**Jamal Solaimanian, PHD., P.E
Engineer Supervisor Permits Branch, Office of Water Quality
Arkansas Department of Environmental Quality
5301 Northshore Drive
North Little Rock, AR 72118-5317**

I would like to go on record stating that the C&H Hog Farms draft permit 5264-W was improperly approved by ADEQ and should be denied. The information I am presenting in my discussion, I feel is relevant. It includes historical and current information about storage and land application of liquid waste from a swine facility based on documents provided by ADEQ website.

C & H HOG FARMS GESTATION-FARROWING FARM AS BUILT ENGINEERING PLAN SHEETS

**Re: Major Modification Request – Waste Storage Pond Liners and Cover
AFIN: 51-00164, Permit No.: ARG590001**

Side by side comparison of select sheets from the NOI and the "As Built" Engineering Plans

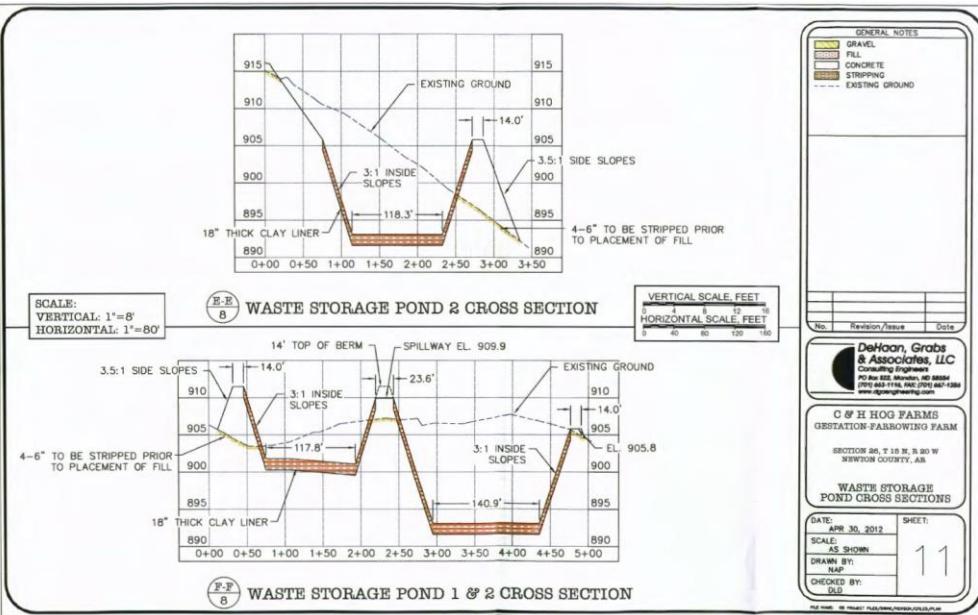
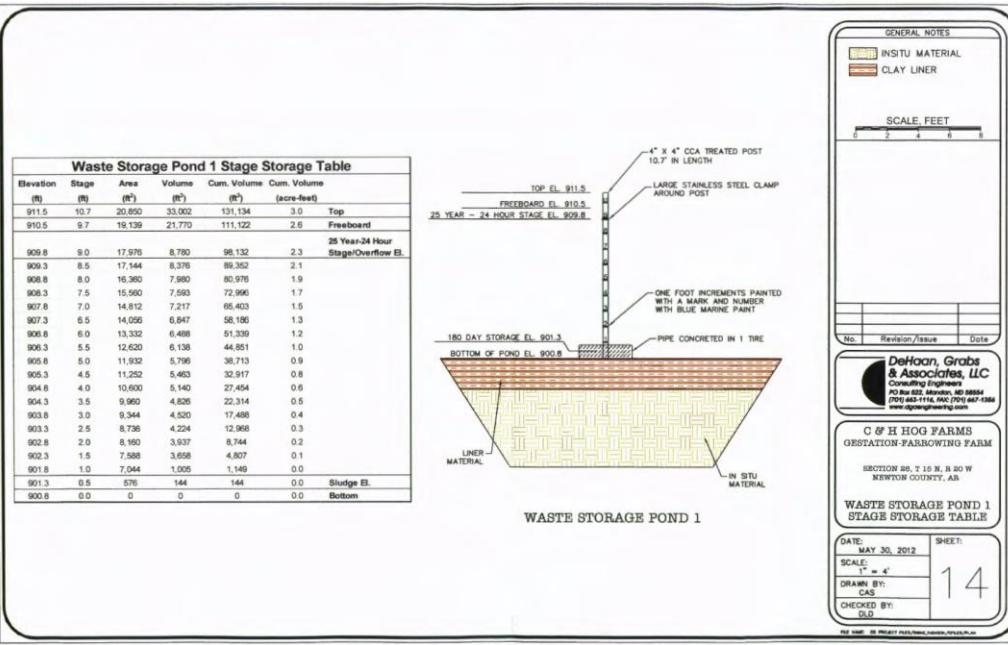
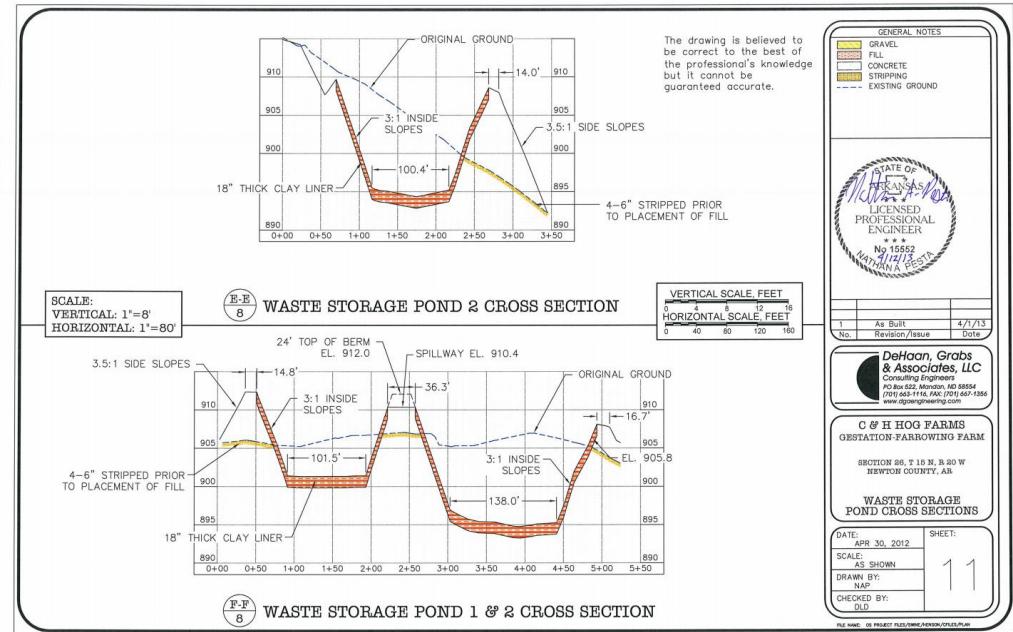
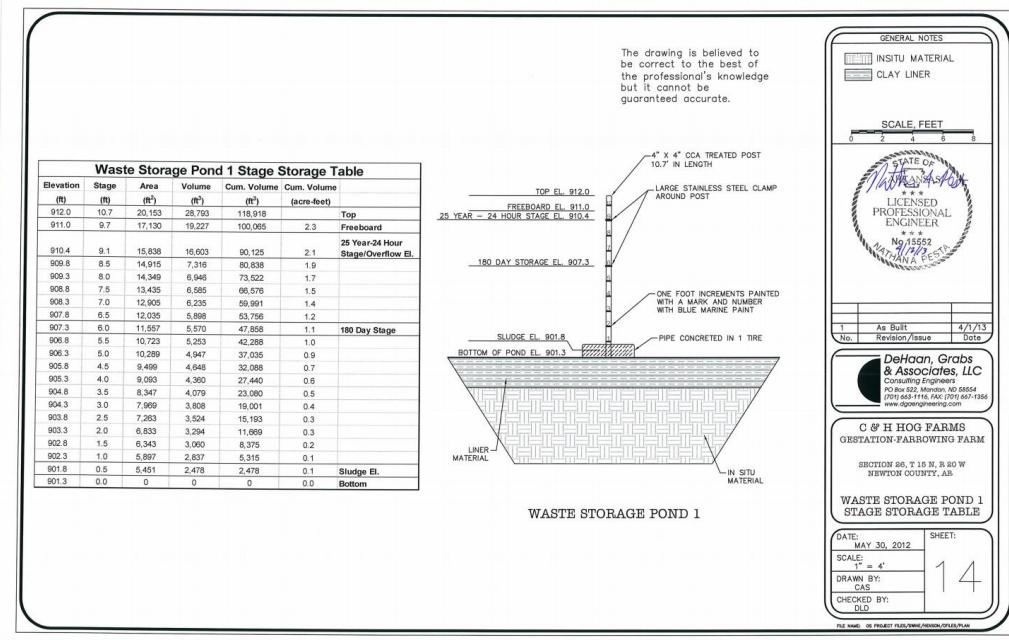
Appears to be MISSING sheet 15: "**WASTE STORAGE POND 2 STAGE STORAGE TABLE**"

Important information like:

"25 Year-24 Hour Stage/ MUST PUMP DOWN" or "25 Year-24 Hour Stage Overflow El."

"As Built" - Engineering Plans

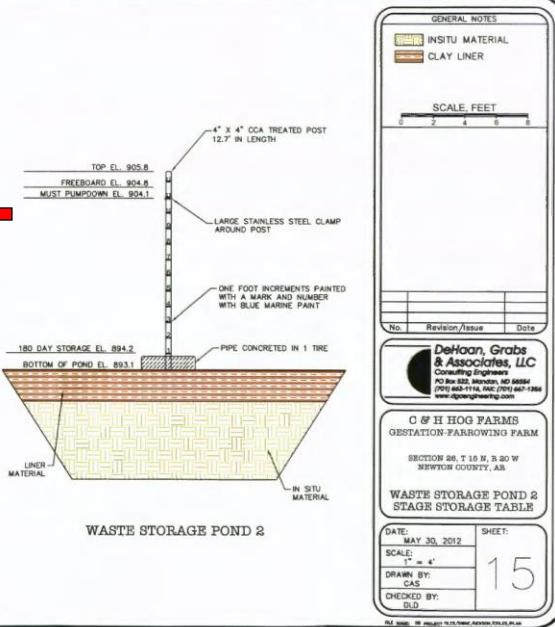
Appears to be MISSING Sheet 15:

"WASTE STORAGE POND 2 STAGE STORAGE TABLE"

"25 Year-24 Hour Stage/Must Pump Down"

"25 Year-24 Hour Stage Overflow El."

Harbor SURVEYED BORING LOCATION C & H HOG FARM - SITE LAYOUT MAP MT. JUDEA NEWTON COUNTY, ARKANSAS **ADEQ**
ARKANSAS Department of Environmental Quality

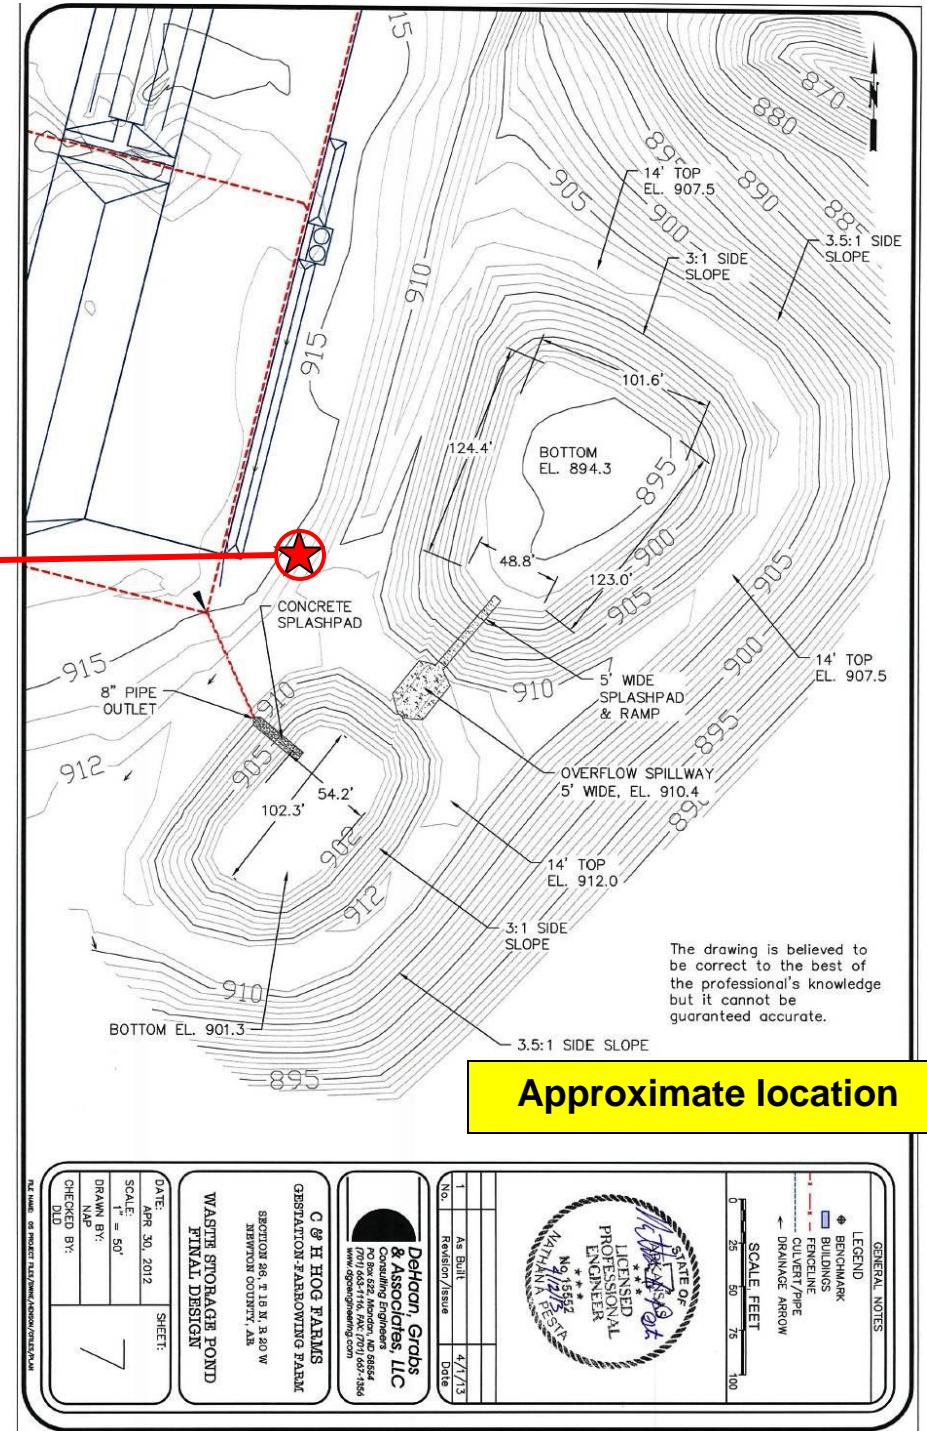
Surveyed Boring Elevation = 930.61'?

Both drawings are certified by the State of Arkansas. Please explain the actual surface elevation for the Harbor Drilling Study borehole that all of the subsurface data was referenced to (BGS).

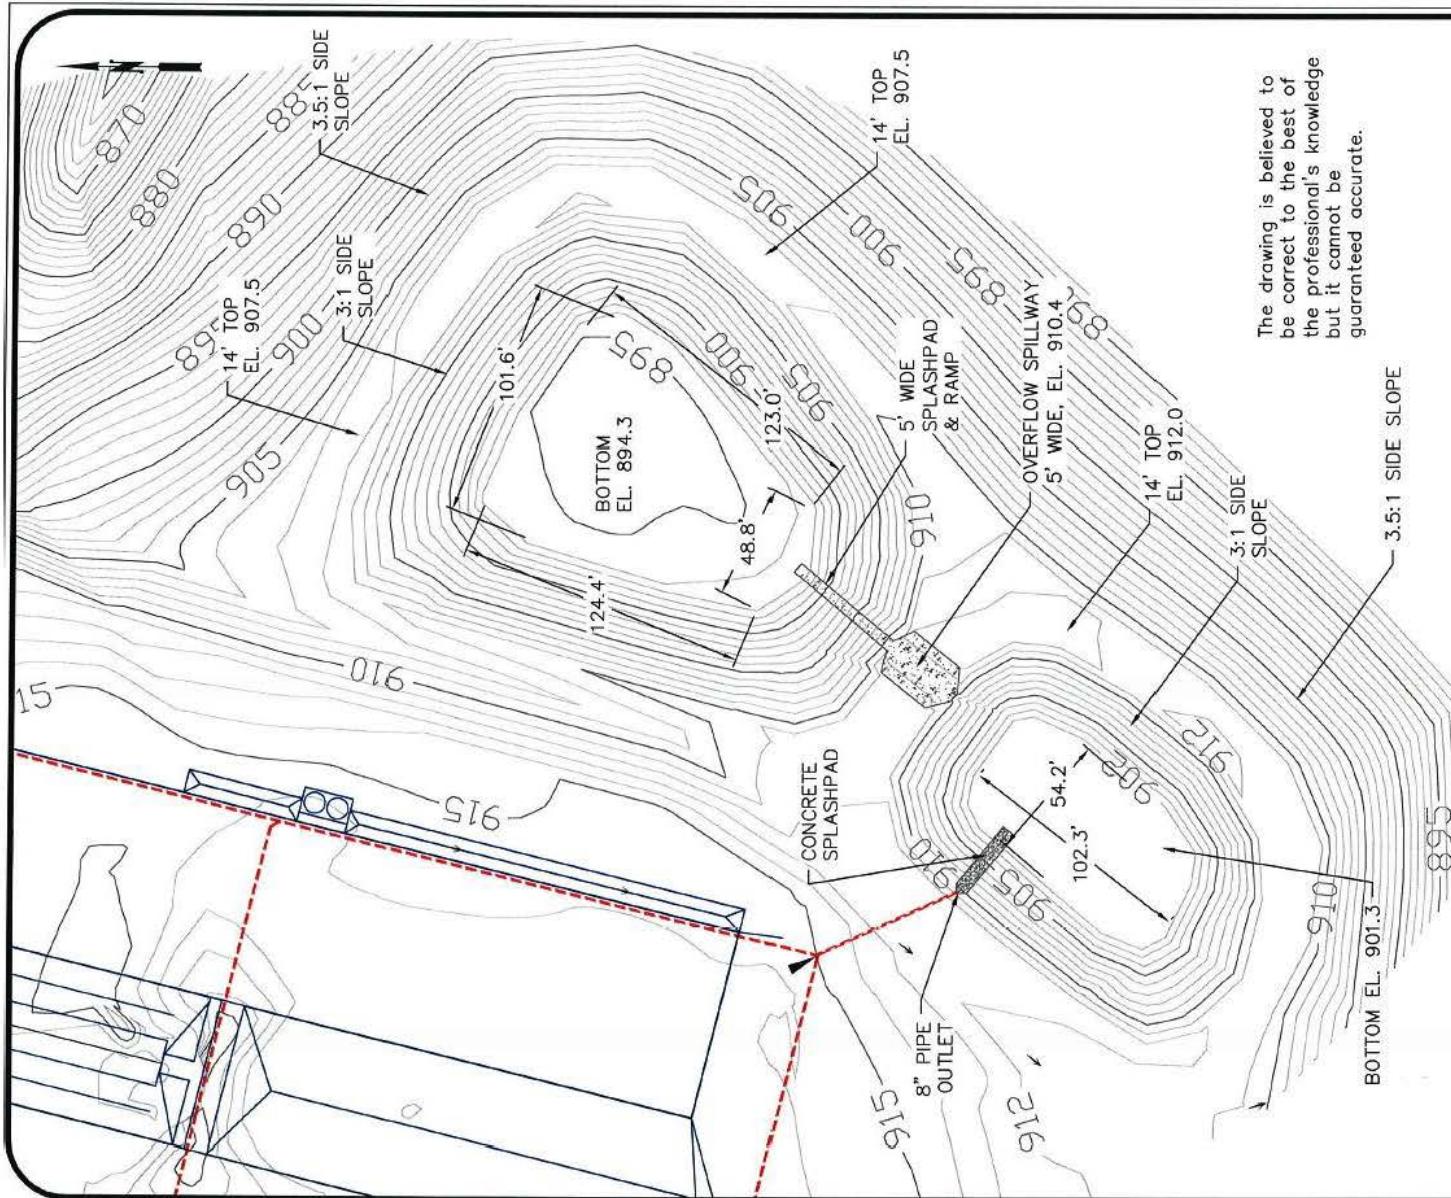
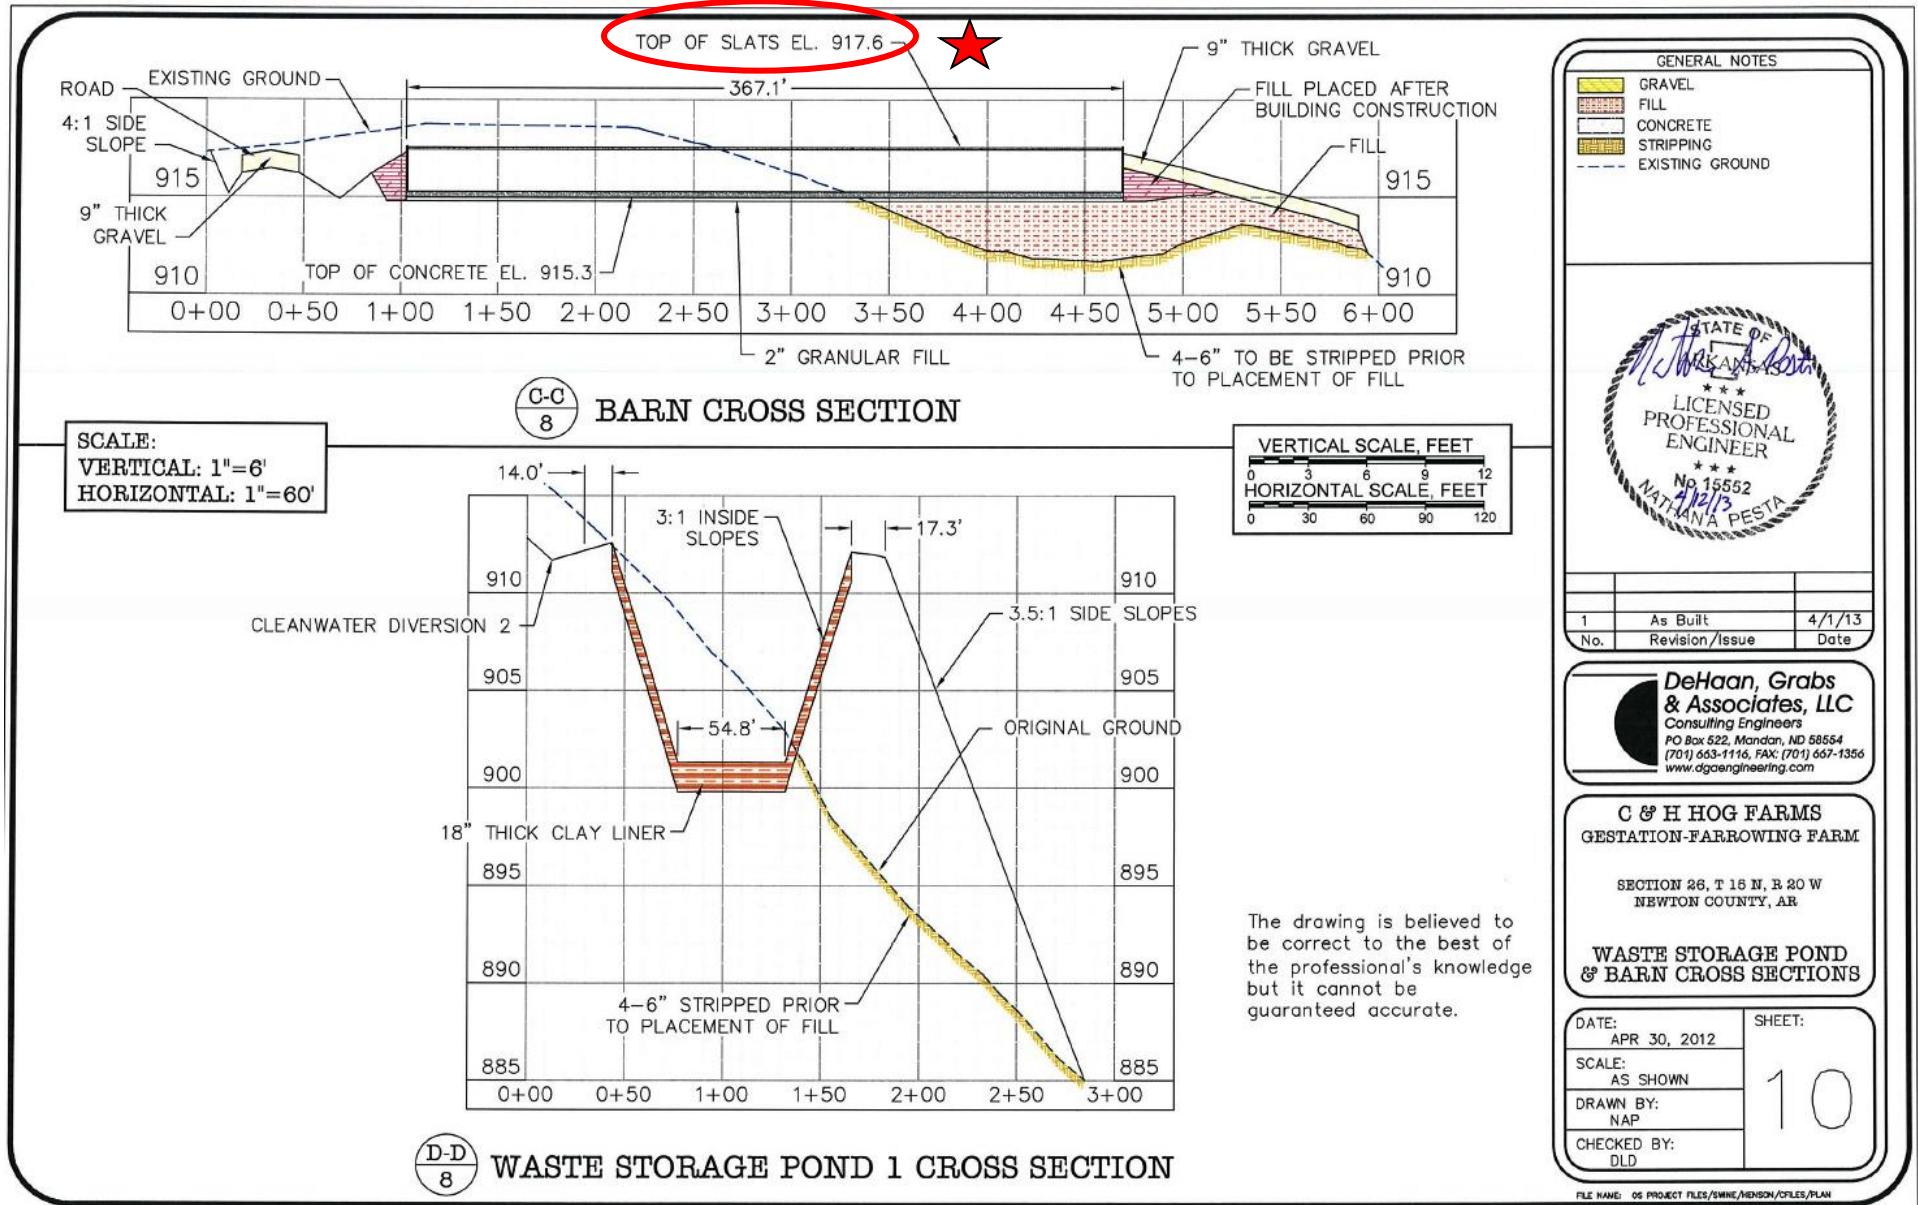
Elevations appear lower in elevation than the
“Surveyed Boring Location”
930.61'?

The surface elevation for the “Top of Slats” (Barn Floor) = 917.6’

The state certified “Surveyed Boring Location” borehole is at surface elevation = 930.61’ but physically appears lower in elevation than the Barn Floor.
